BVY 08-040

**SUBJECT: Vermont Yankee Nuclear Power Station
License No. DPR-28 (Docket No. 50-271)
Request for Revision to Existing 10 CFR 50 Appendix R Exemption**

Attachment 1 - Basis for Revision of Existing Exemption from 10 CFR 50 Appendix R,
Section III.G.2.b

Figure 1 - Fire Zone RB-3 Layout

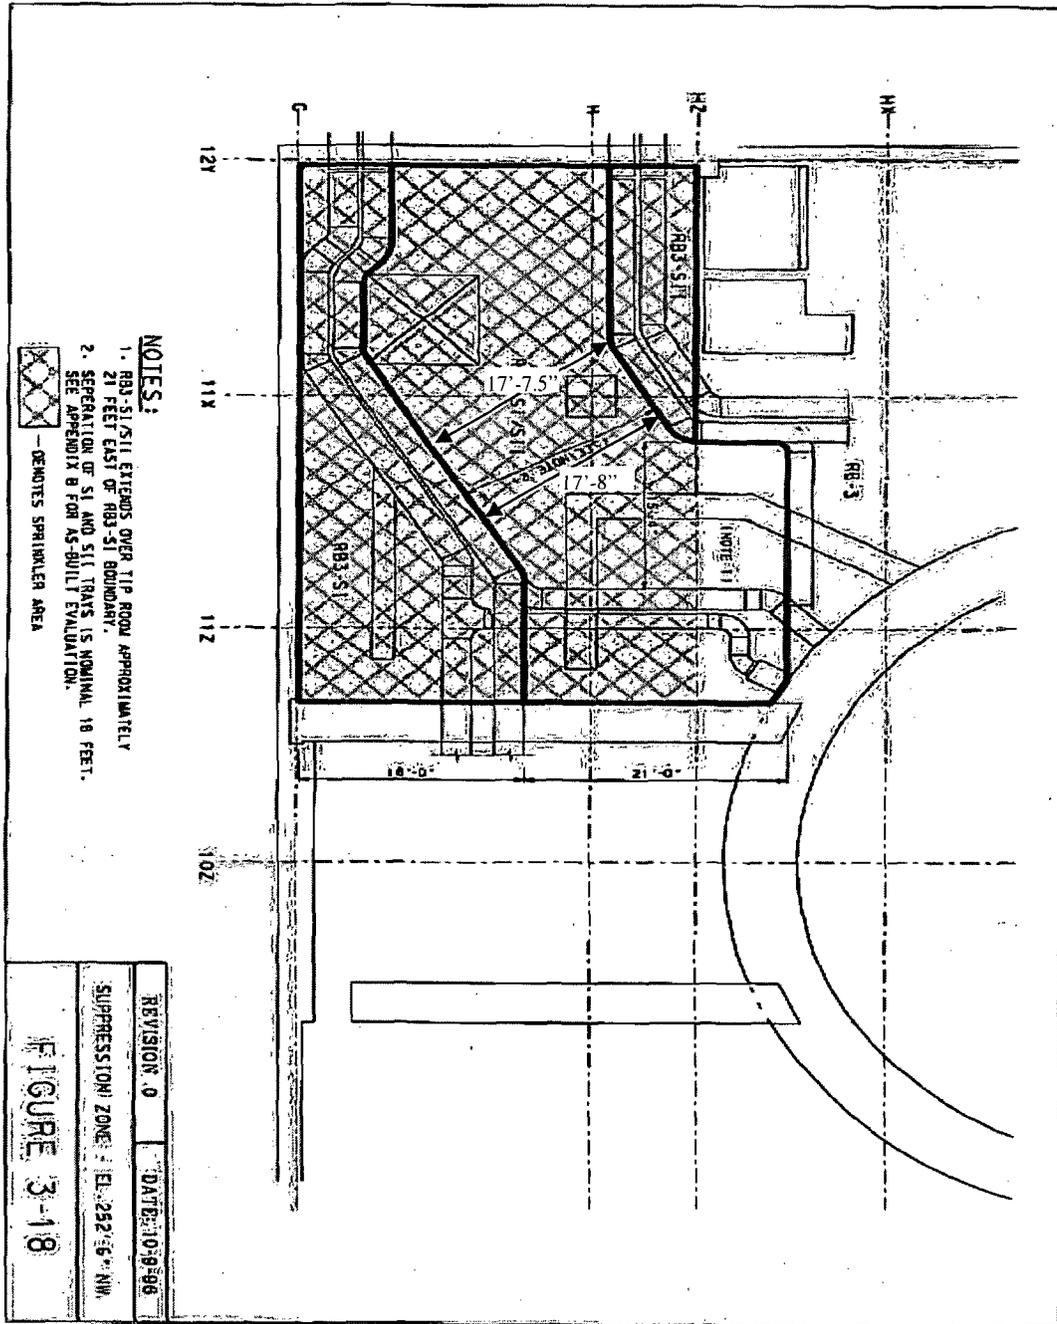
The VY re-evaluation of Appendix R compliance performed a detailed exemption request compliance review which included actual physical measurements in overhead areas of the minimum separation distance between trays. VY determined that the minimum 18' of spatial separation existed where the trays entered the reactor building from the cable spreading room, but in one area, for about a 10' horizontal distance, there is less than 18' of separation. This area is shown in Figure 1. Along this length, the minimum separation distance was found to be 17'-7.5".

The 4.5" deviation from the identified 18' separation distance is considered to have no adverse impact on the bases for approval of the exemption. While the exemption was requested due to not meeting the 20' separation criteria of Appendix R, the primary fire protection features used to justify the exemption were the existing detection system in the northwest corner, the suppression system coverage at both ceiling level, below tray and conduit obstructions closer to the floor, the lack of intervening combustibles between cable trays to propagate a fire, and protection for any redundant safe shutdown cables located in between the cable tray systems.
